Access Compliance Report

Public Rights-of-Way

Intersection ID: 12760	Main Street: 7TH_ST	Cross Street: N_MYERS_ST	Location: W
ADA ID: 6BD323152F81	Ramp Type: PerpDiag	Initial Pass/Fail: Pass	Overall Compliance: No
Severity Score: 0.25			
Codes/Mitigation Info/Possible Solution		Field Measurements/Component Compliance

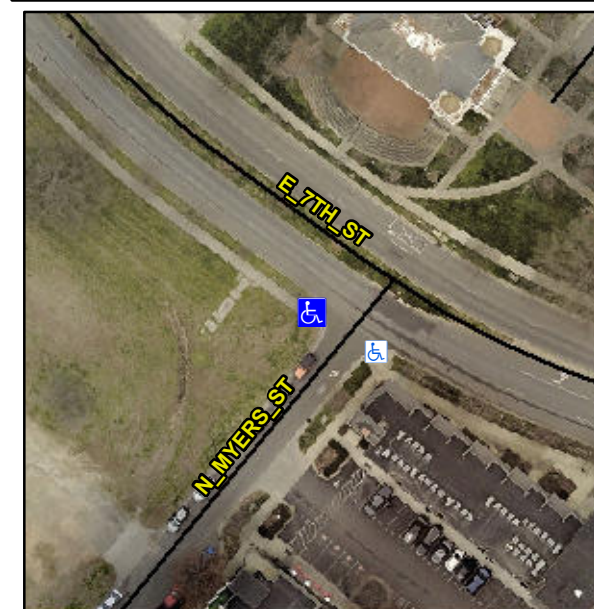
Not Found, R304.5.3, R304.2.1, R304.2.2-Perp, R304.3.2-Para, R305.2

Compliance	Description	Data	Compliance	Description	Data
N/A	Ramp Length (in)	60.0	Yes	Ramp Slope (%)	5.4
Yes	Ramp Width (in)	48.0	No	Ramp XSlope (%)	3.5
N/A	Flare Type LT	Sloped	N/A	Flare Type RT	N/A
N/A	Flare Slope LT (%)	1.7	Yes	Flare Slope RT (%)	8.3
N/A	Flare Traversable LT?	Yes	N/A	Flare Traversable RT?	Yes
No	Landing Length (in)	26.0	Yes	DWS Provided?	Yes
Yes	Landing Width (in)	48.0	Yes	DWS Contrast?	Yes
No	Landing Slope (%)	2.4	Yes	DWS Length (in)	24.0
Yes	Landing X Slope (%)	0.6	Yes	DWS Full Width?	Yes
N/A	Landing Curb? (Y/N)	No	No	DWS Offset (in)	5.5
N/A	Shared Landing?	No			
Yes	Gutter Ponding?	No	Yes	Gutter Slope (%)	4.3
Yes	Gutter Lip Ht (in)	0.0	No	Gutter X Slope (%)	3.3
N/A	Painted X Walk1?	No	N/A	Painted X Walk2?	No
	X Walk 1 Direction	To SE		X Walk 2 Direction	To NE
N/A	X Walk 1 Width (in)	N/A	N/A	X Walk 2 Width (in)	N/A
	X Walk 1 Slope (%)	2.4		X Walk 2 Slope (%)	0.9
	X Walk 1 X Slope (%)	4.0		X Walk 2 X Slope (%)	2.2

Remove & Replace Curb Ramp With Two New Directional Ramps or Equivalent. Remove & Replace Gutter.
